DESIGN REVIEW BOARD WORK SESSION

**Design Review Board Case # 2020-XXXX
Block P – 765 John Carlyle – South Tower**

Block P – DRB Work Session

Illustration B: Height of Retail Canopies – Current Proposal

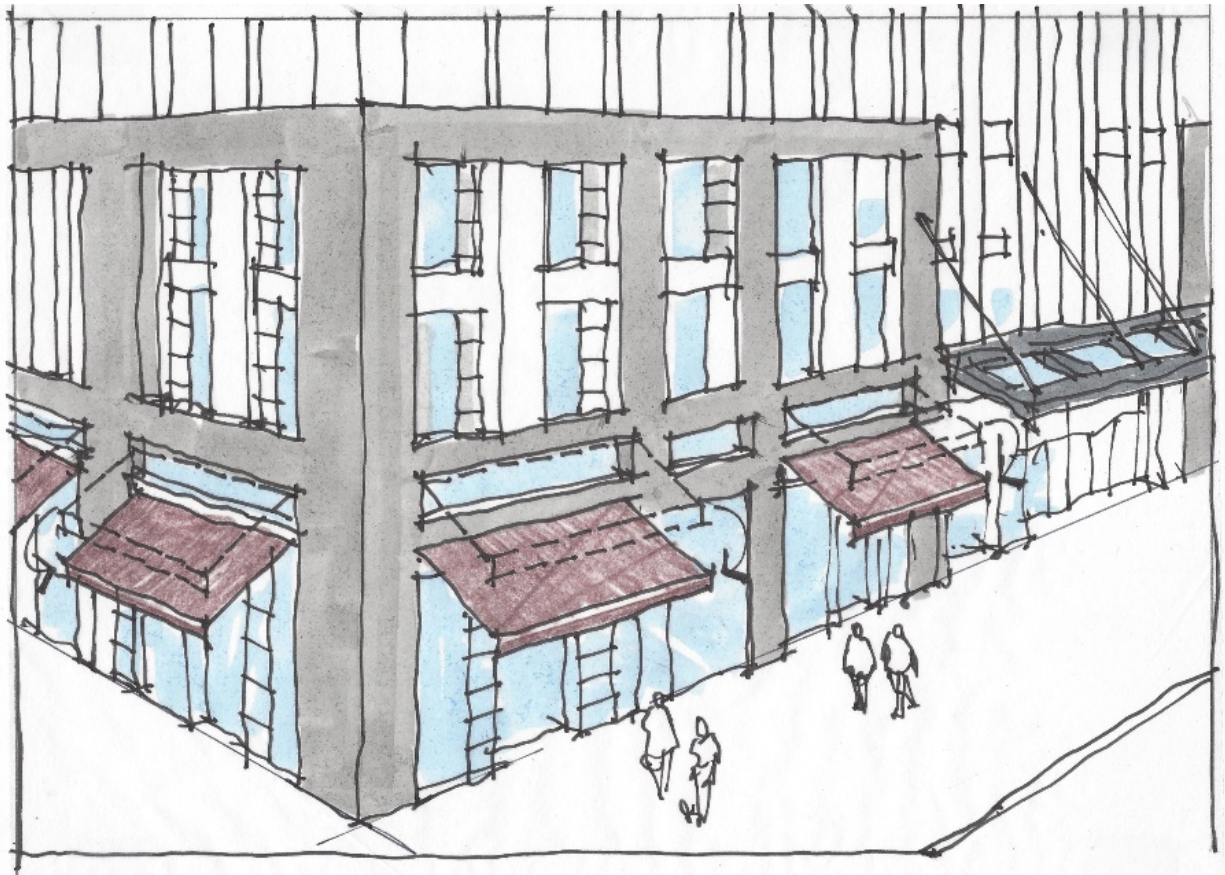
#22 The fabric awnings shown in the current design, while proposed to be fixed on stationary metal frames, still have the appearance of retractable ones in the rendering; further, they appear to be located very high relative to the pedestrian scale. In the interests of scale, weather protection, and opening up the views through the significant transom glass shown, staff suggests lowering the awnings to the next lower building element, a substantial horizontal that separates the storefront glass and transom. An added benefit of this adjustment would be to clearly show the hierarchy that separates these awnings from the metal and glass canopy at the main lobby entrance (Illustration B, below).

Illustration C: Approved Garage Screening at North Tower

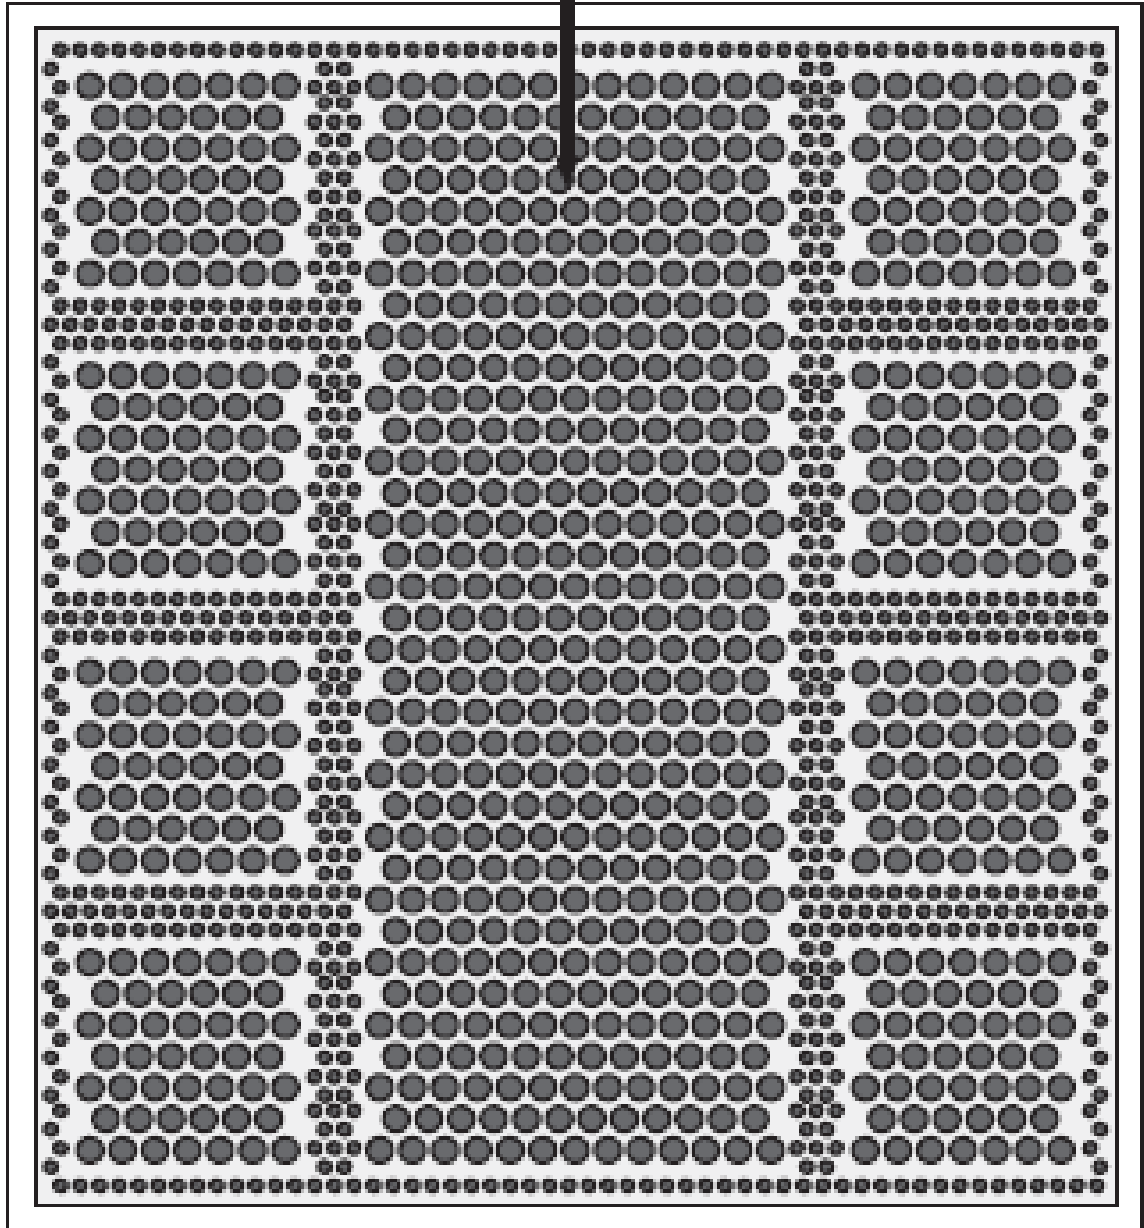
While the previous design was approved with above-grade, naturally-ventilated parking, the screening as approved (and as still proposed for the revised north tower) incorporated a richly-detailed combination of glass, custom louvers, and mullion framing that mitigated the visual impact of the parking (Illustration C, below). Staff does not support the current proposal for the parking screening of the south tower, which proposes to mimic the mullion pattern in the tower above through varying the density of perforations in a large surface of what appears to be flat, perforated metal (Illustration D, below).

Illustration E: Garage Screening Approved for WMATA VA HQ

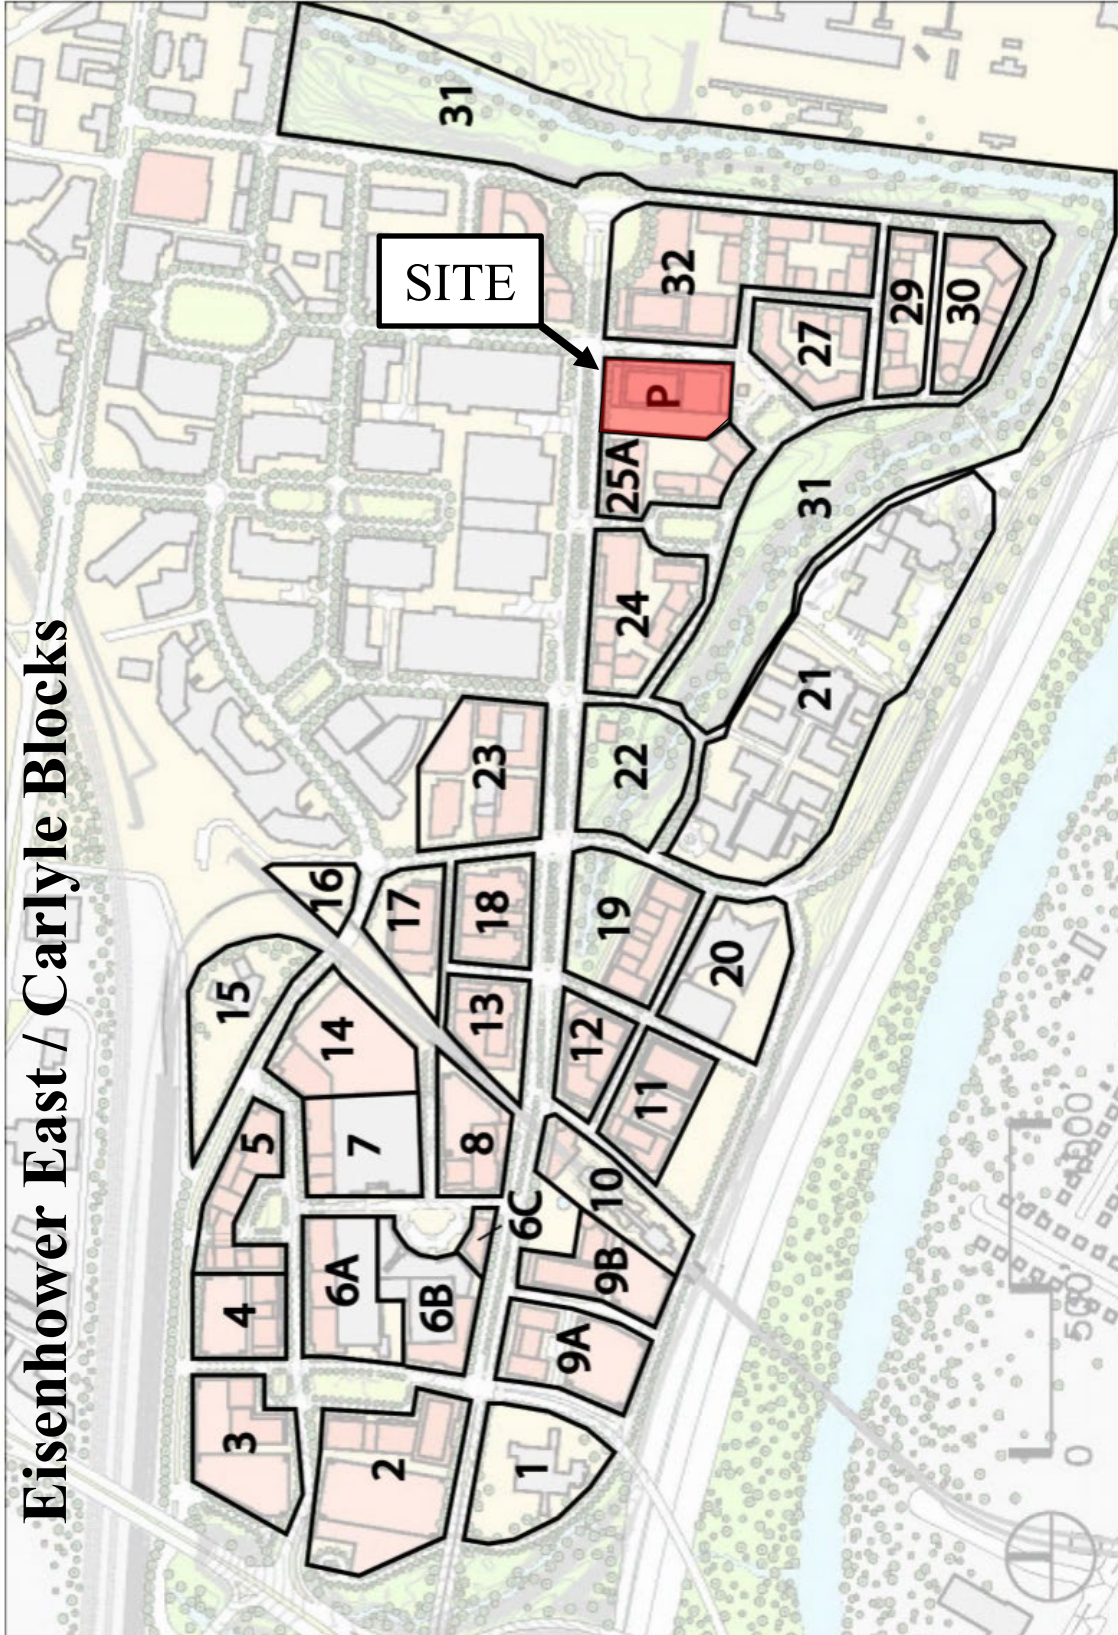
Staff does support the idea of carrying the subdivision pattern from the glazed openings above down into the parking levels, and differentiating the south tower screening from that in the north

tower, but requires a solution that incorporates a variety of depths, along with a variety of materials (preferably including glass) for some portions of the enclosure. A similar solution was proposed and approved by the DRB for the above-grade parking levels of the WMATA Virginia Headquarters building, currently under construction along Mill Road in Eisenhower East. As in the case of the North Tower, elements of the occupied floors enclosure system above are carried down through and incorporated into, the parking screening system (Illustration E, below).
